Access Compliance Report

Public Rights-of-Way

Intersection ID: 12274	Main Street: BERRYHILL_RD	Cross Street: MORTON_ST	Location: NE
ADA ID: AC27698904BD	Ramp Type: Combination1Diag	Initial Pass/Fail: Fail	Overall Compliance: No
		Severity Score: 0

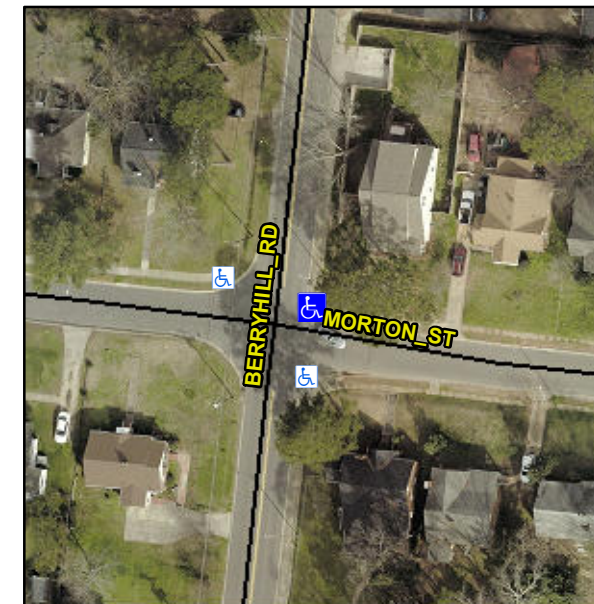
LT RP < 5%

Not Found, R304.5.1, R304.5.3, R304.3.2

Remove & Replace Curb Ramp With Two New Directional Ramps or Equivalent.
